**RELICENSING STUDY 3.3.8**

**COMPUTATIONAL FLUID  
DYNAMICS MODELING IN THE  
VICINITY OF THE FISHWAY  
ENTRANCES AND POWERHOUSE  
FOREBAYS**

**ADDENDUM**

**Northfield Mountain Pumped Storage Project (No. 2485)  
and Turners Falls Hydroelectric Project (No. 1889)**

Figure 2.17-6: Cabot Fishway Scenario 5-3 Near-Powerhouse Velocities, Scaled to 0-15 fps

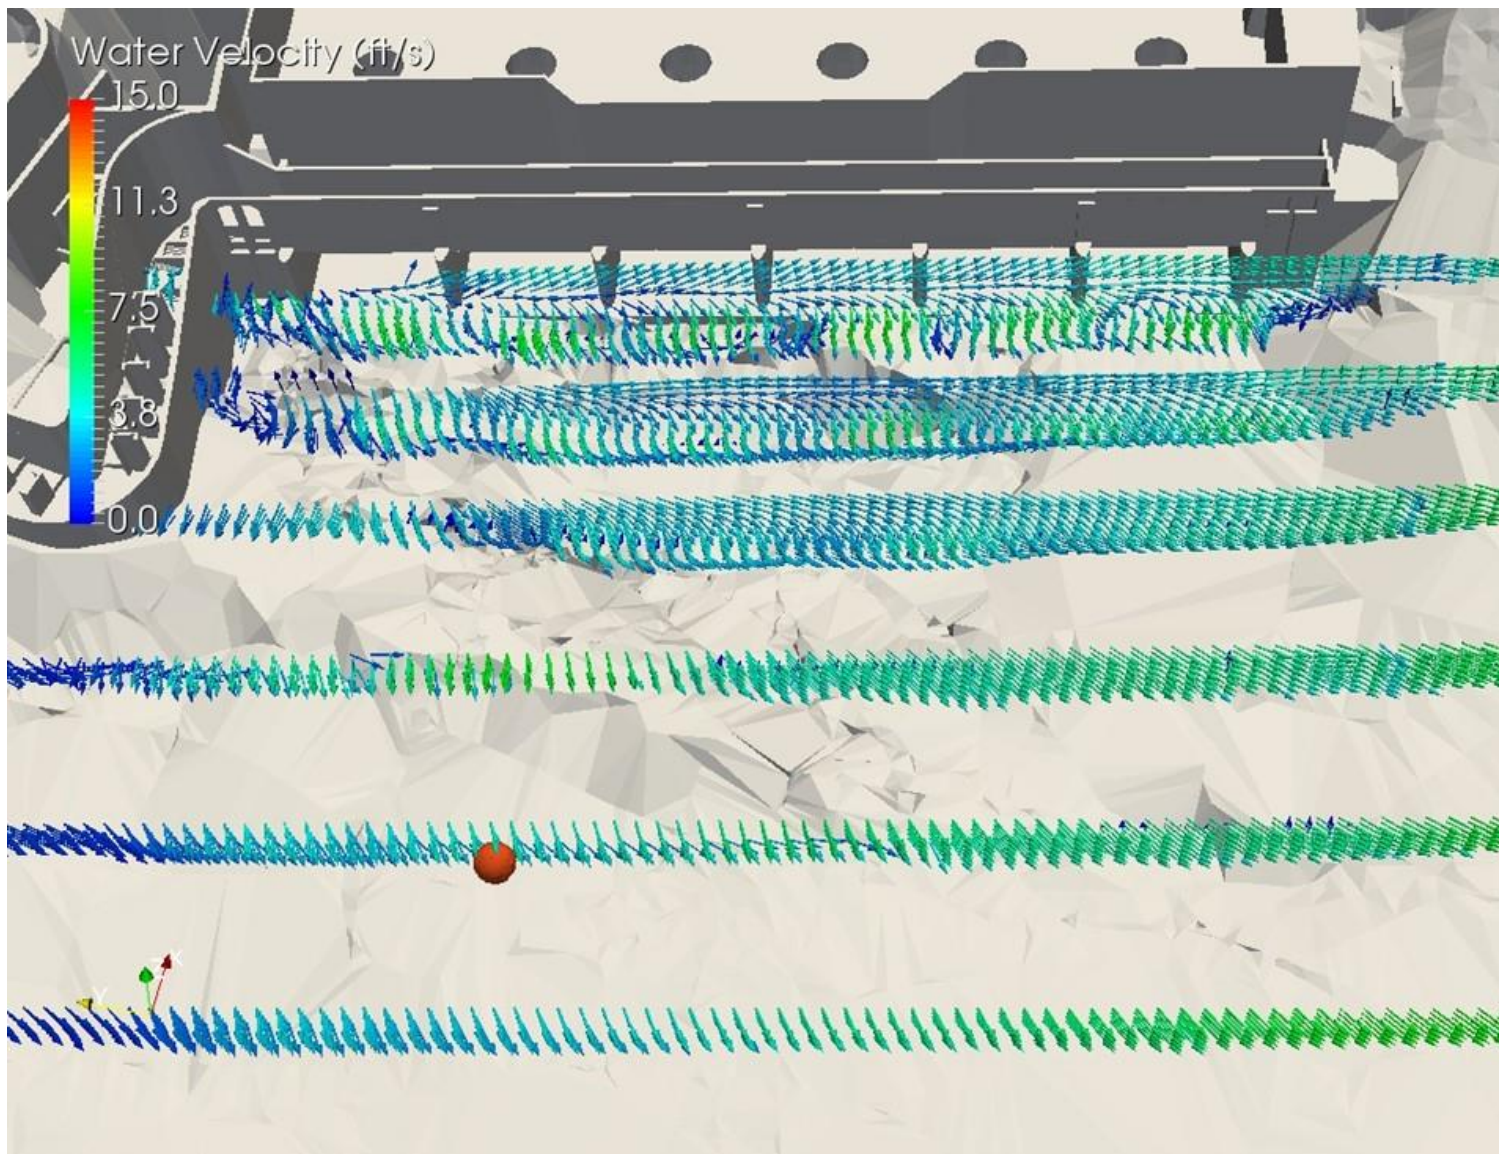
Comment: For Production Runs 5-1 through 5-5: Figure 1 shows the area to be revised for several figures in the report whereby each of these types of figures should be zoomed into the yellow box and another cross section at the red line should be added.

These figures have been generated and are shown in [Figures 2.17-1](#) through [2.17-10](#).
